**Request for Bid
 Wolf River Interceptor Rehab Addendum # 1 to
 RFB No. 194677.71.0397
 January 30, 2017**

Section 1 – Mandatory Pre-Bid Meeting Notes, Bidder Questions and Sign-In Sheet

Section 3 – Updated Technical Specifications, Drawings, and Special Instructions

WOLF RIVER 96" REHABILITATION

PROPOSED 10" SEWER LAYOUT

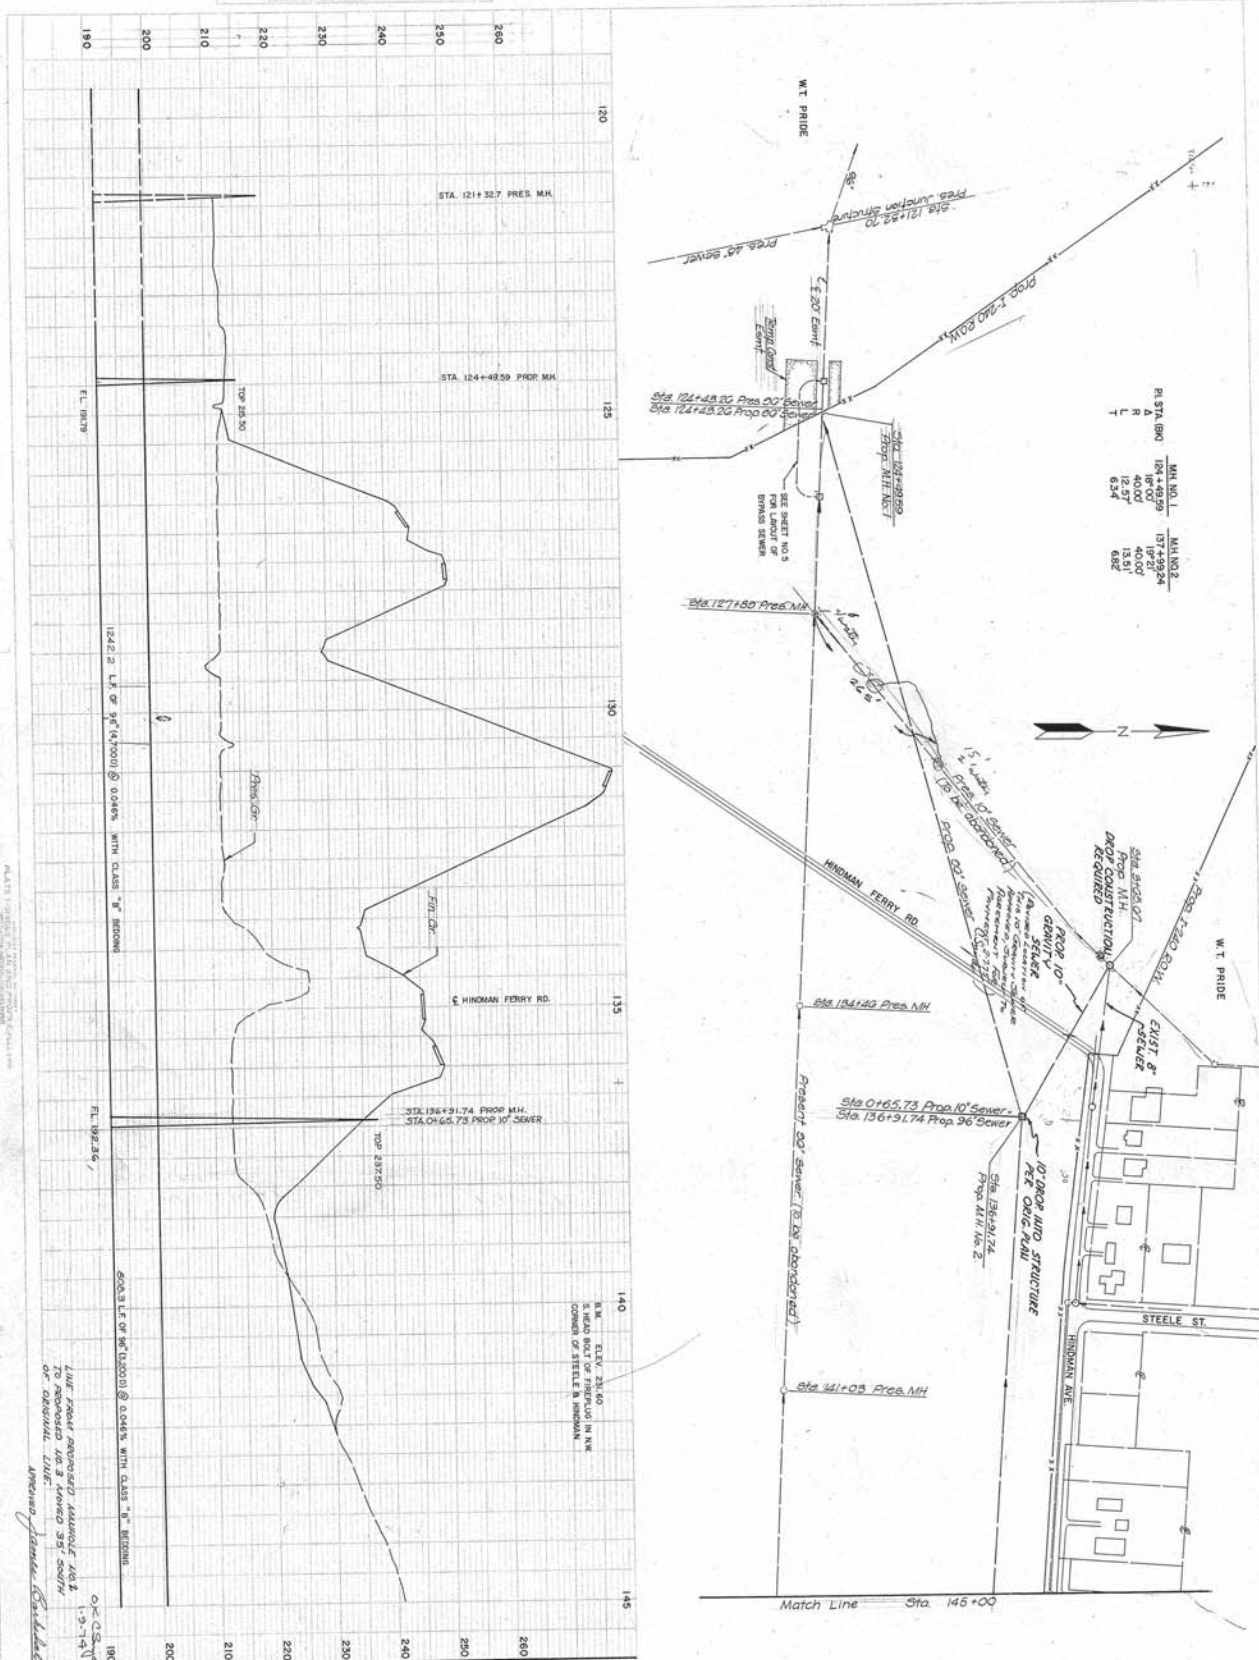
Q10: Are there as-built drawings available and will they be available?

Q11: Do the as-built drawings include slopes and grades?

SARP10: They are included in this Addendum.

SARP10: Yes, see question 10.

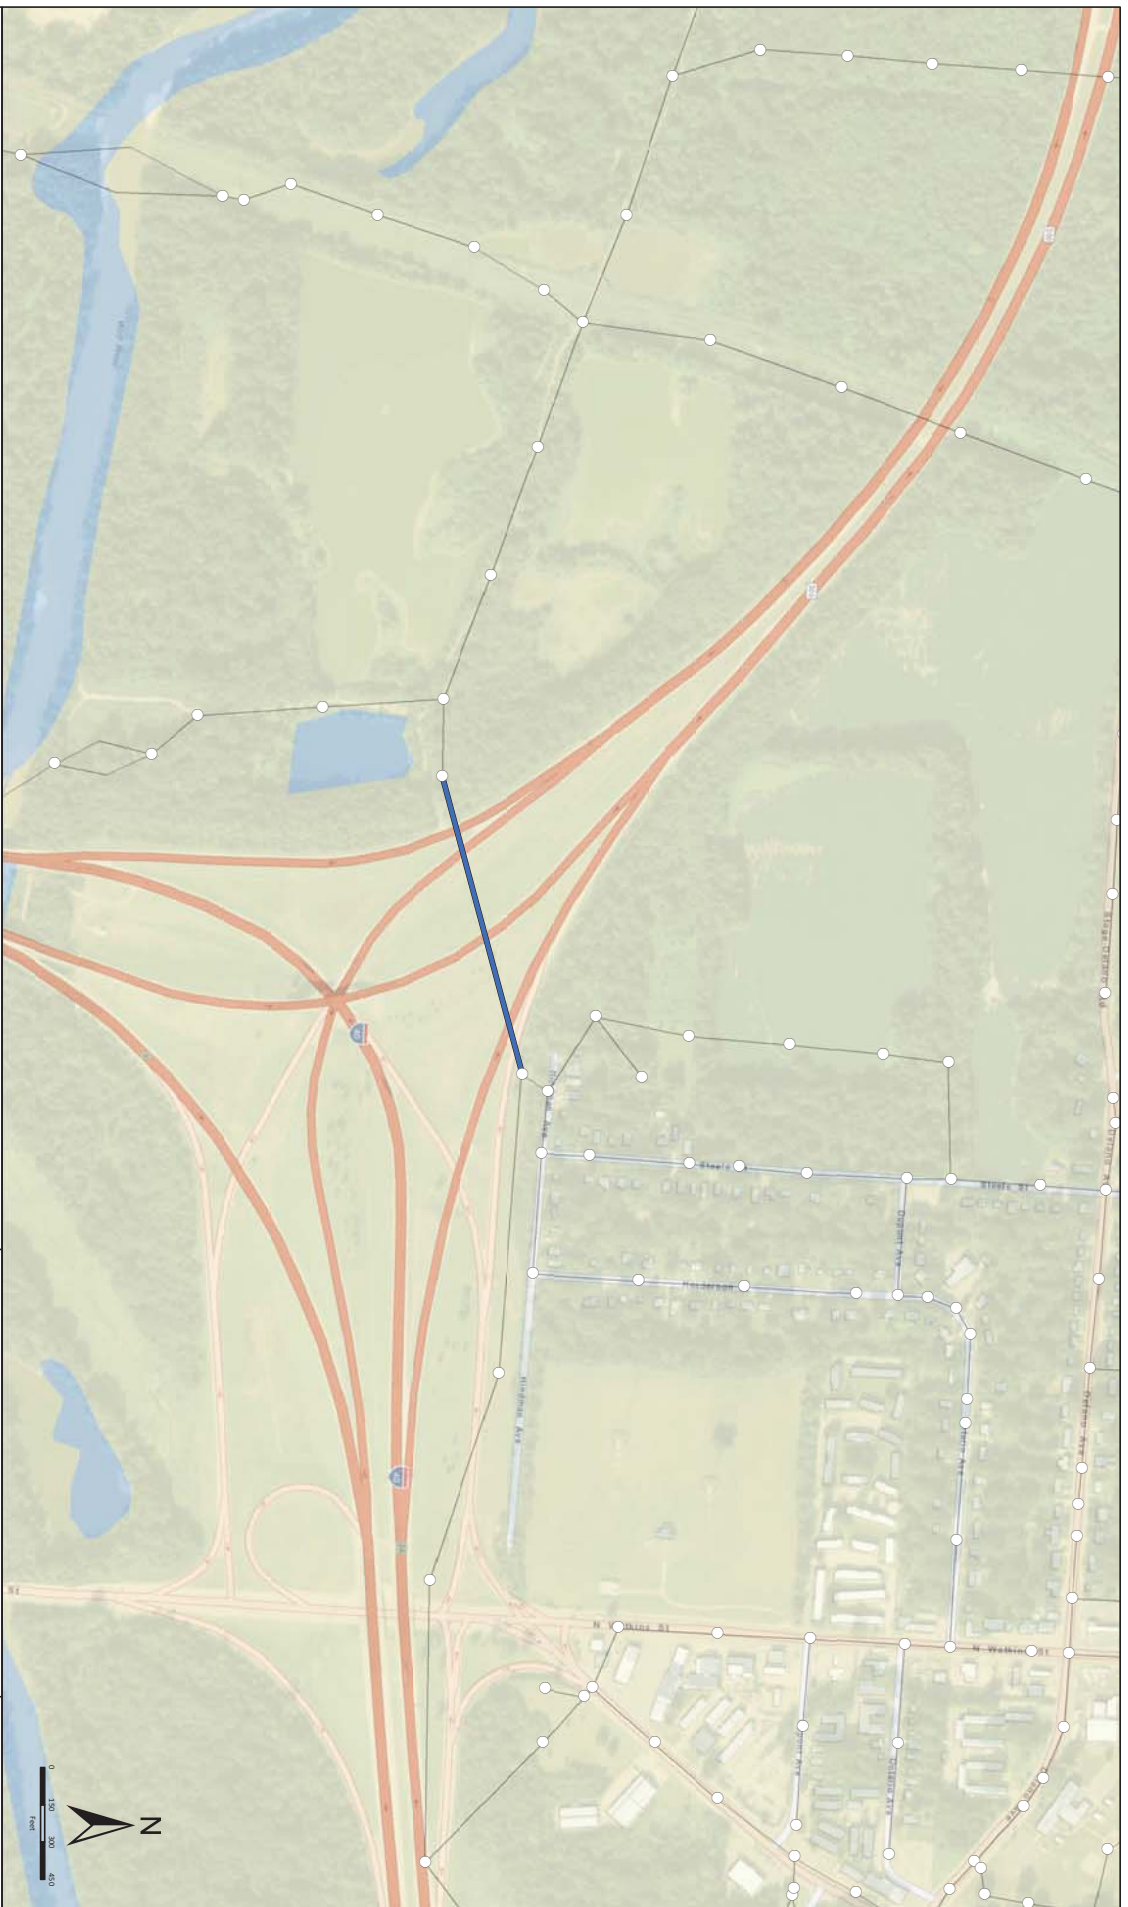
- Q3:** Can you revise the map to include surveyed information?
SARP10: A map with surveyed manholes attached in this Addendum.
- Q4:** What direction is the flow and how does it continue once it is to the west?
SARP10: The sanitary sewer continues on a west ward path.
